# Product Change Notice (PCN)

PCN Number: **PCN-0450882R-01**

Product(s) Affected: **PJ1-022-SMT-TR**

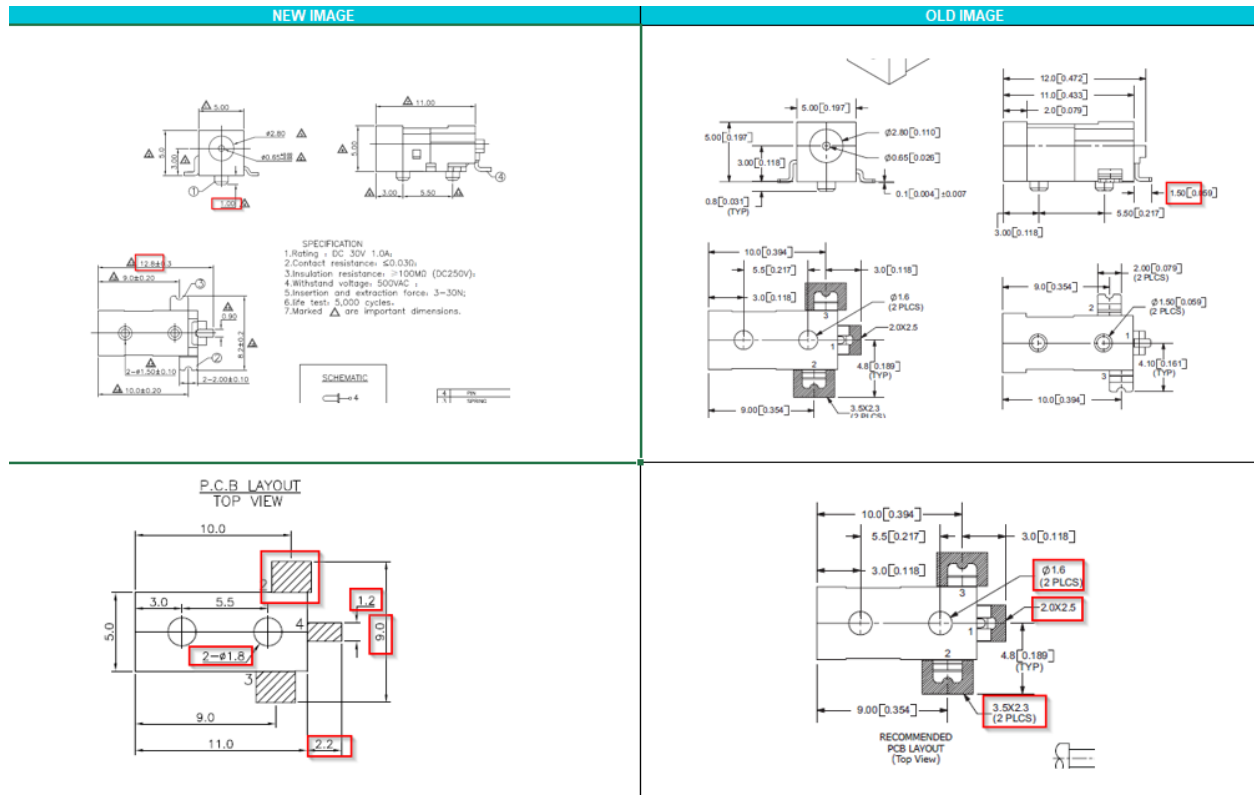
Description of Change: **Minor Housing and footprint differences. Material Change on the housing and terminals. See image Below**

Housing and Terminal Material Changes:

Center Pin: Brass to Bronze  
Terminal 2: Copper Alloy to Brass  
Plastic: PA6T or Equivalent to PA10T
